These drawings are for a non-material amendment application to the previously approved design, reference '22/1164/FFFU'. Changes annotated on the drawings & are as follows:

Project Address
**24 Park Avenue, Camberley,
GU15 2NG**

Sheet Title
Plans - Ground Level - Proposed GA

Sheet Ref.	MAP-C4813-101	Rev.	0
Project Ref.	C4813	Date	14.02.2024
Drawn by	FM	Checked by	JMS
Scale	1 : 100	Sheet Size	A1

Proposed Ground Level Plan
General Arrangement | 00-FLL | Scale 1 : 100

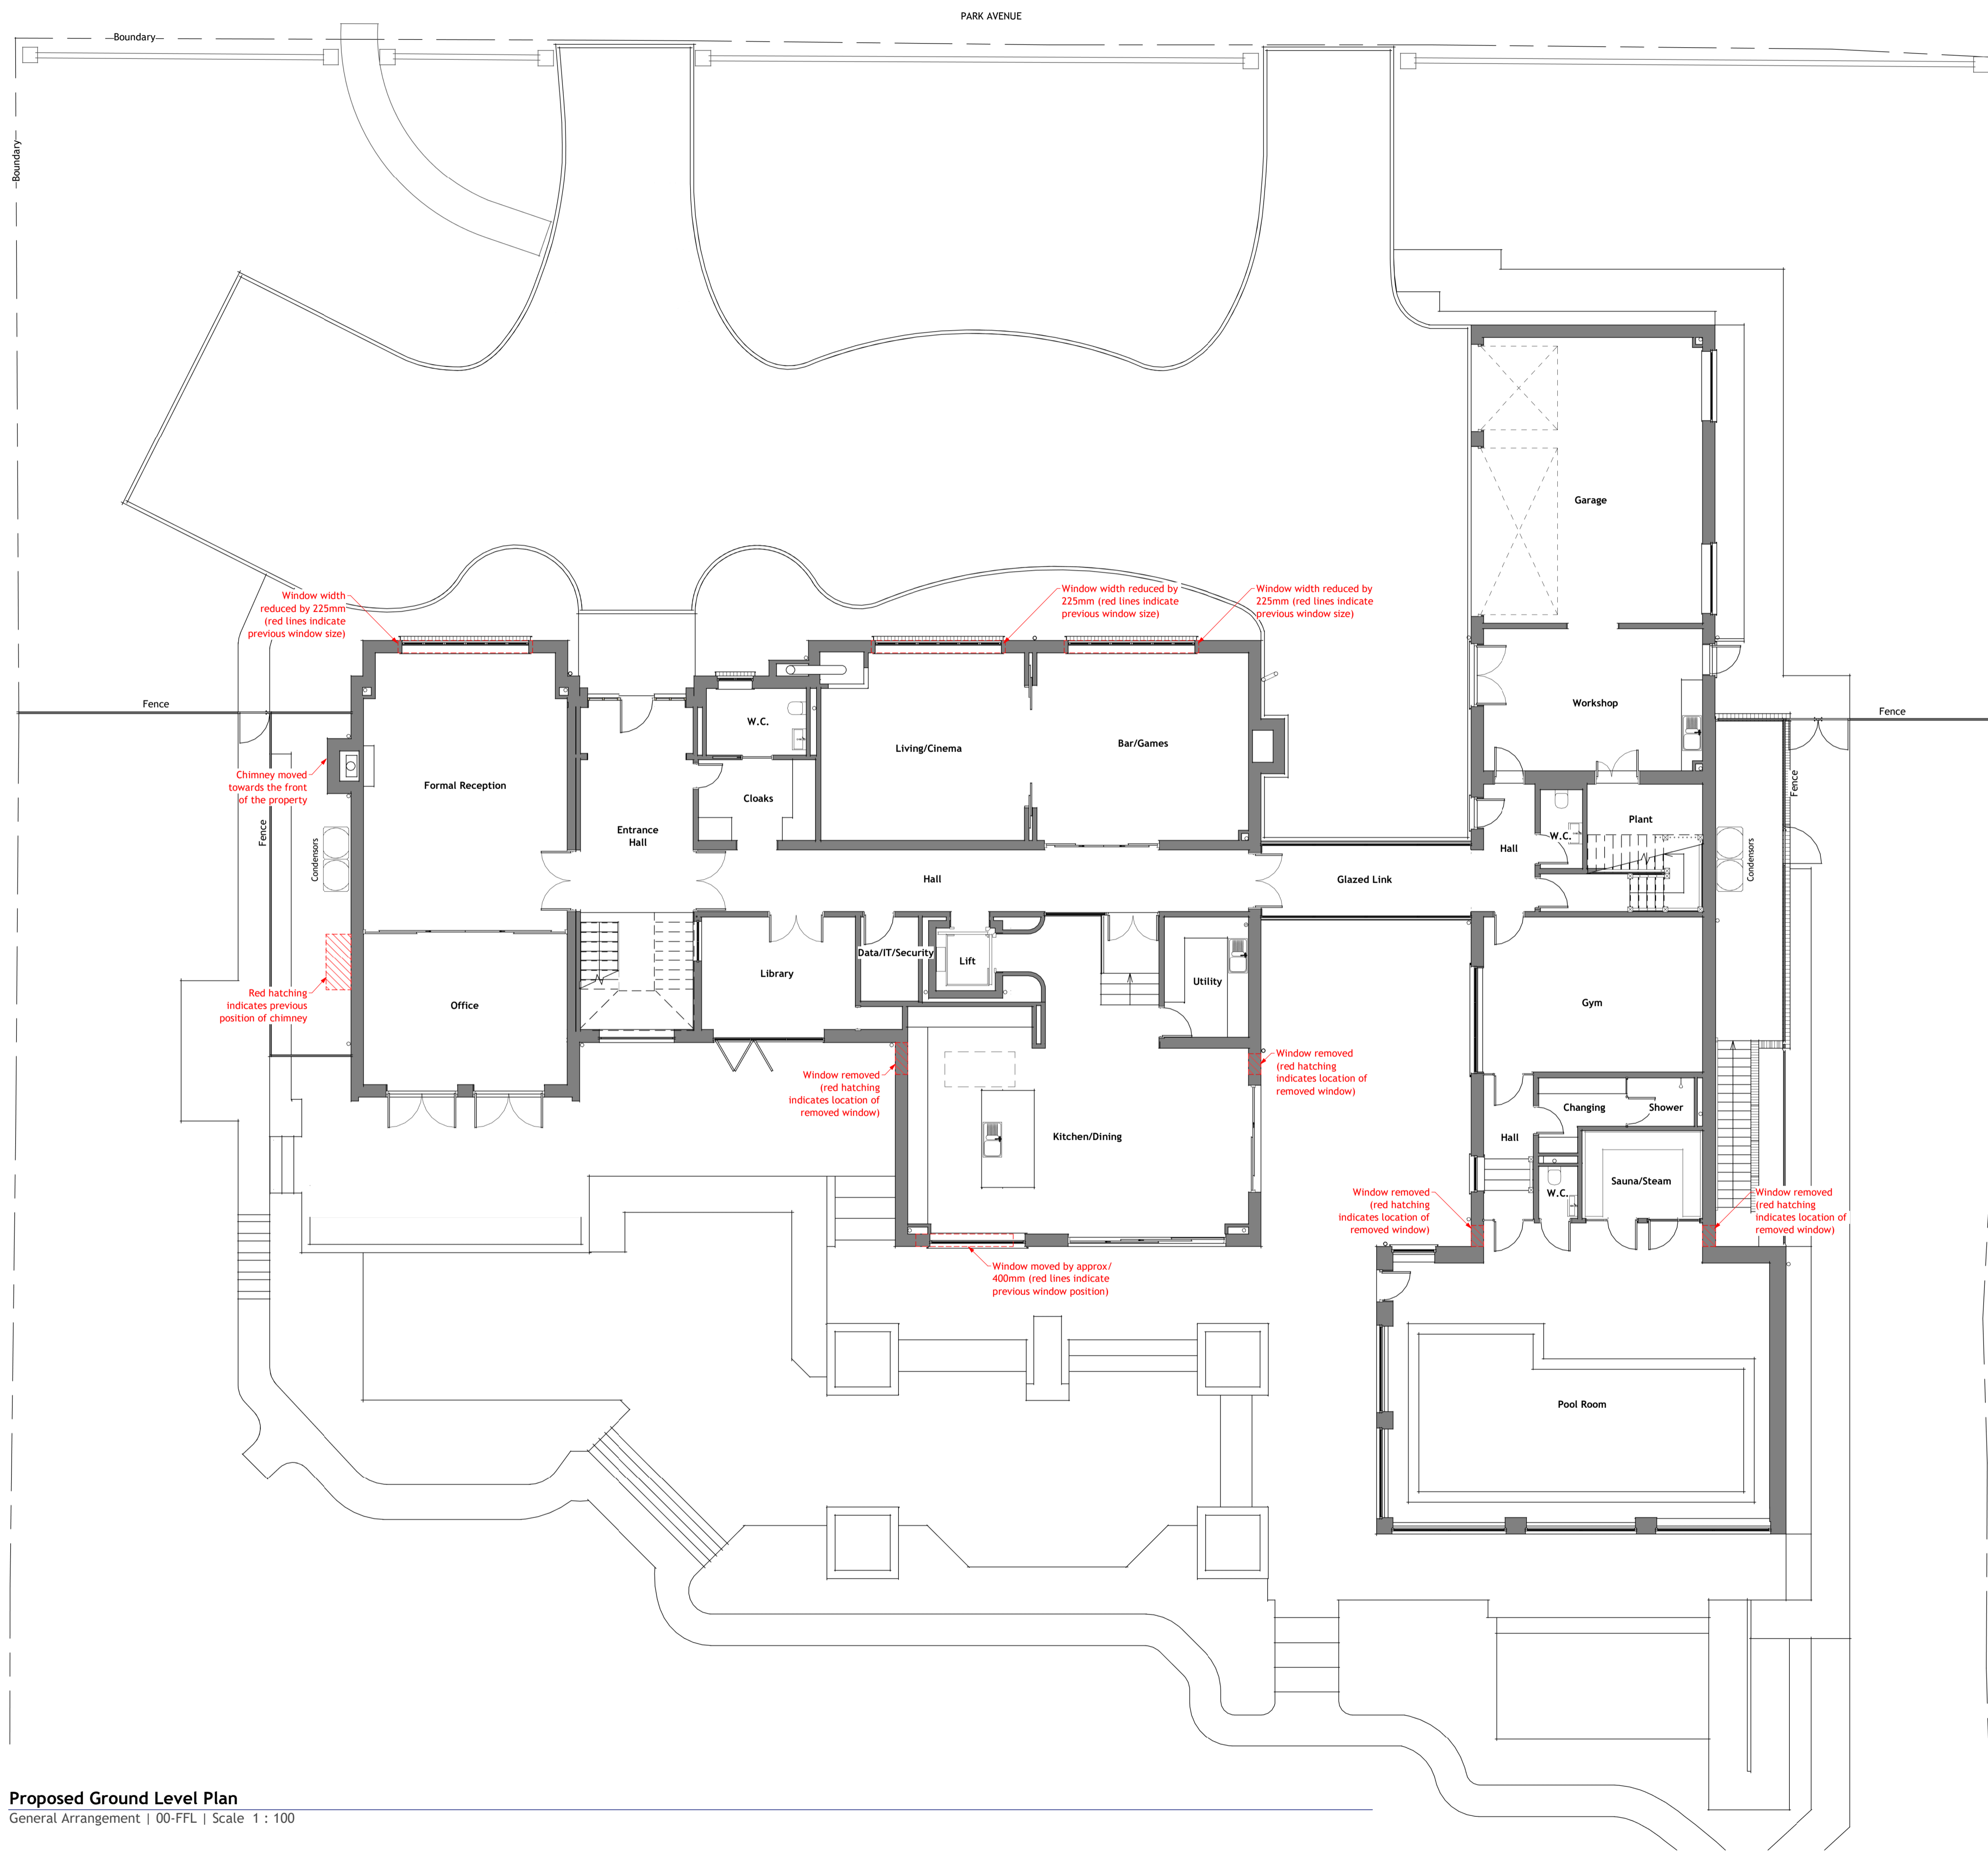
1. Windows size & position revised as shown on plans & elevations
2. Windows removed as shown on plans & elevations
3. New window in the east elevation of the house
4. West chimney moved towards the front of the house as shown on plans & elevations
5. Dormer windows position adjusted as shown on plans & elevations
6. House roof eaves raised & roof pitch reduced by 1No. degree as shown on elevations
7. 2No. rooflights added as shown on plans & elevations
8. Glass roof removed as shown on plans
9. Annex roof rear overhang extended as shown on plans & elevations
10. Annex East wall partly rendered behind fence as shown on elevations
11. Flat rooflight added as shown on plans
